**Monks Orchard
Residents' Association
Planning**

Reference: 25/01471/FUL
Application Received: Wed 30 Apr 2025
Application Validated: Wed 30 Apr 2025
Address: 21 Woodmere Gardens Croydon CR0 7PL
Proposal: Demolition of single-family dwelling and garage and the erection of 4 bungalows 1 x 3 bed and 3 x 2 bed. Provision of 6 off road parking spaces.
Status: Awaiting decision
Case Officer: Christopher Grace
Consultation Close: Mon 02 Jun 2025
Decision Deadline: Wed 25 Jun 2025

Please accept this letter as MORA's formal comment with respect to **Application Ref: 25/01471/FUL** for Demolition of single-family dwelling and garage and the erection of 4 bungalows 1 x 3 bed and 3 x 2 bed. Provision of 6 (8) off road parking spaces.

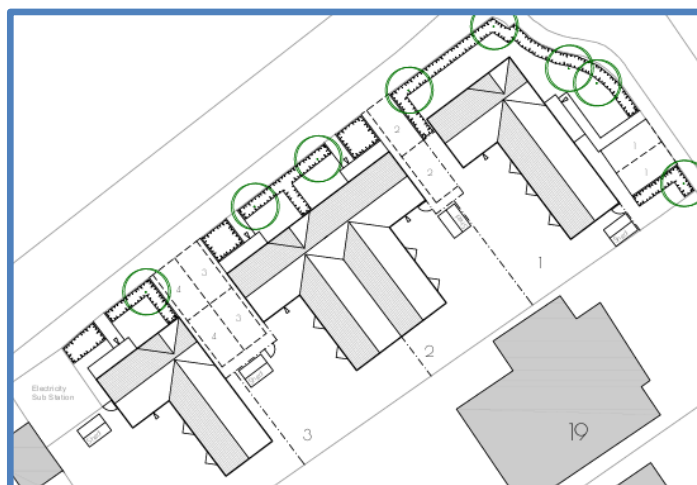
- a) The Application Documentation lists **6 off-street parking bays**, but the plans provided indicate **8 off-street parking bays**.
- b) There are provisions for **Built-In Storage Space** of $\approx 1.3\text{sq.m.}$ located within the kitchen/dining/living accommodation area. However, this does not meet the London plan Requirement **Table 3.1** or **Best Practice LPG Housing Design Standards - Table A1.1**.

- c) There is no **Disabled Parking Bay** ($\leq 10\%$) nor any indication of whether **Electric Vehicle Charging Points** are provided.
- d) There is no provision for **Cycle Storage** as the **PTAL** is the lowest value at **Zero** but again, this could be the subject of a condition.

- e) There are no identified provisions for the **required Refuse/Recycling Bins** for each unit, or their position to be used on collection days.
- f) The **Floor Area Ratio (FAR)** is **0.26** which is acceptable (≤ 0.5) for **Area Type Outer Suburban**.

Block Plan of the site

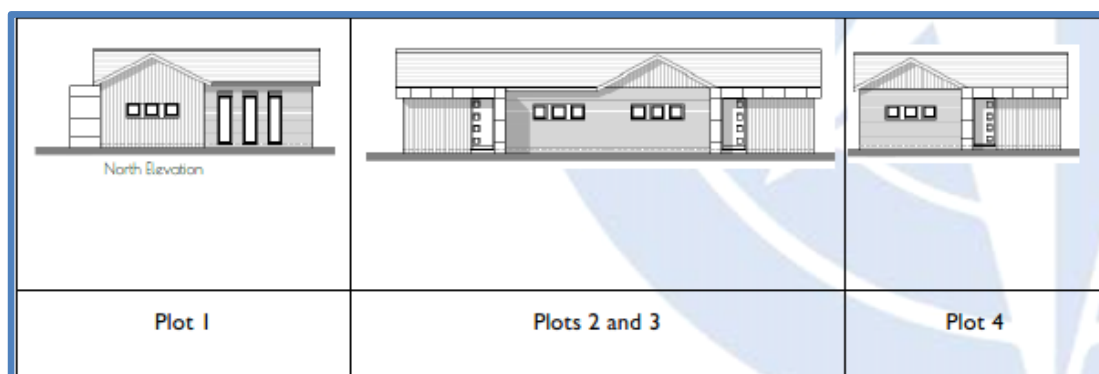
- g) The **footprint - Gross External Area (GEA)** is not provided or has not been found in the supplied documentation. The **Footprint** as measured from the scaled block diagram at magnification **112%** (where **1cm \equiv 2m**) provides an estimate at $\approx 182.70\text{ sq.m.}$ This gives a **Plot Area Ratio (PAR)** of $182.70/1220 \approx 0.15$ which after all requires space for **Car Parking, Refuse Bin Storage, Cycle Storage, etc.**, means there is a very small allocation for **Urban Greening or Garden Area** for **Area Type Outer Suburban at PTAL 0**. The Average **Plot Area Ratio (PAR)** for **Woodmere Gardens** as measured by **Google Earth** is ≈ 0.5 .

Unit 3 Parking Spaces as shown on the Block Plan are within the boundary of **Unit 4**.

However, there is no indication of the location of these storage areas on the **Block Plan for storage or on collection days**. It is not considered appropriate for these refuse/recycling Bins to be stored within the provided **Sheds**.

Unit 1 Parking Spaces are accessed from Woodmere Gardens.

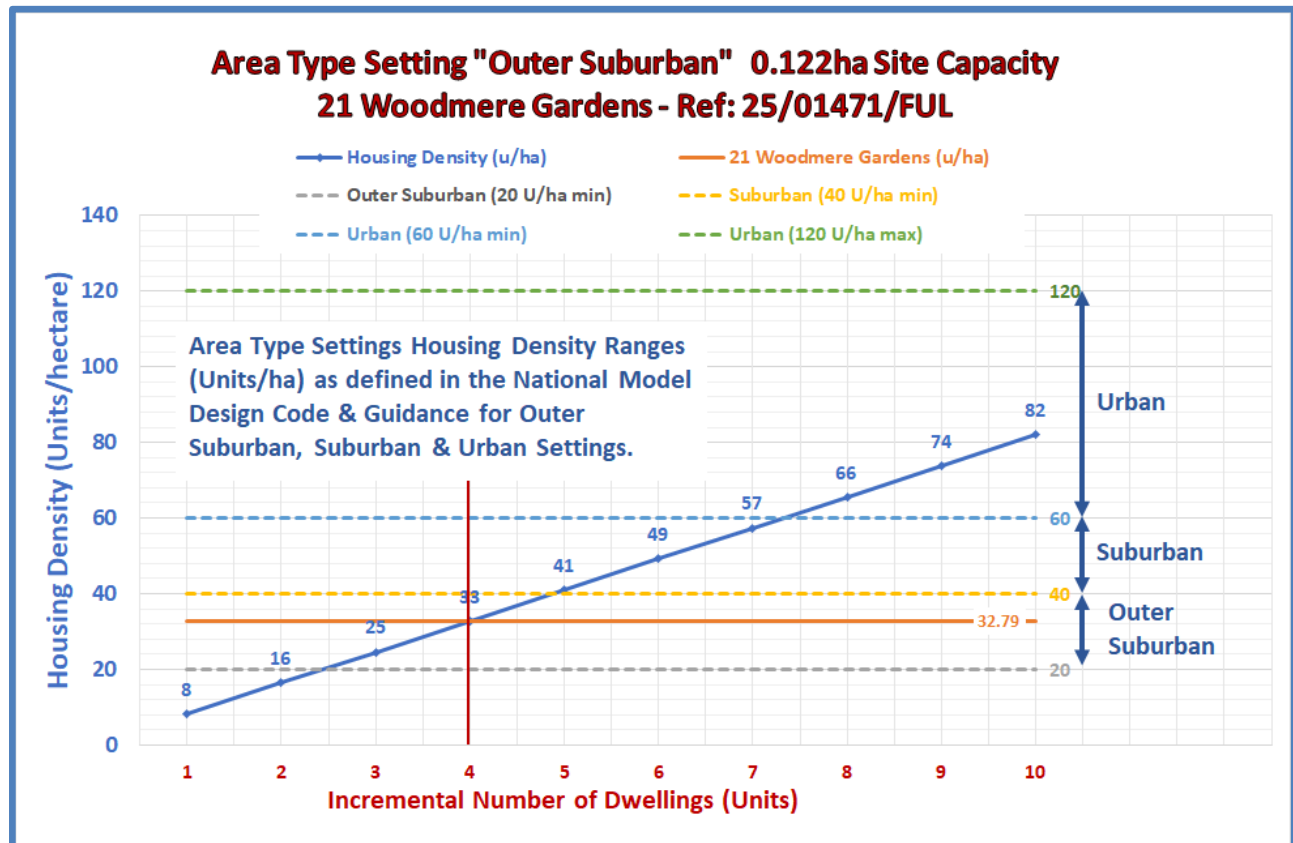
Unit 2, 3 & 4 Parking Spaces are accessed from **Woodmere Avenue** but are double banked requiring the front vehicle to be moved for the rear vehicle to exit. This is an

indication of over development as there is insufficient **Plot Area** for side-by-side parking.
